UNITED STATES PATENT AND TRADEMARK OFFICE

Office Action Summary	Application No. 10/567,452	Applicant(s) FALZONI ET AL.
	Examiner ELIZABETH VOLZ	Art Unit 3781

DETAILED ACTION

Figure 3 (Ingram et al.)

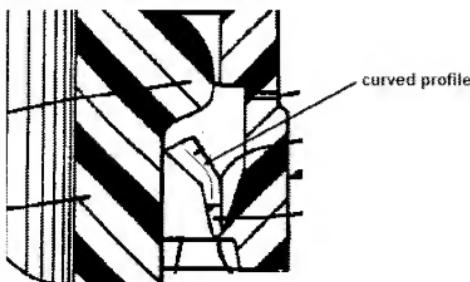
2. Claims 138-150 are rejected under 35 U.S.C. 102(b) as being anticipated by Ingram et al. (U.S. Patent No. 5,611,446).
3. Regarding Claim 138, Ingram et al. discloses a cap arrangement 32 (Figure 2), comprising an opening-indicator device 35 (Figure 2) having an outer edge (Figure 2) wherefrom fin members 40 (Figure 2) lead away and extend, in use, internally of said cap arrangement, said fin members being intended to form an abutment (Figure 13) for projection elements 37 (Figure 3) projecting from a neck 31 (Figure 1) of a container arrangement with which said cap arrangement can be associated, said fin members comprising an elongated element 42 (Figure 2) extending substantially rectilinearly from said opening-indicator device, said fin members further comprising flexible appendage elements 43 (Figure 2) forming a free end of said fin members (Figure 3), said flexible appendage elements having a substantially uniform thickness (Figure 3), said appendage elements having a curved profile (Figure 3 below) adapted to partially surround said projection elements (Figure 13).

25. Applicant argues that Ingram et al. (U.S. Patent No. 5,611,446) does not disclose flexible appendage elements having a curved profile adapted to partially surround projection elements on a neck of a container arrangement with which the cap arrangement can be associated. However, as shown in the above rejection, Ingram et al. does disclose a curved profile and is adapted to partially surround projection elements.
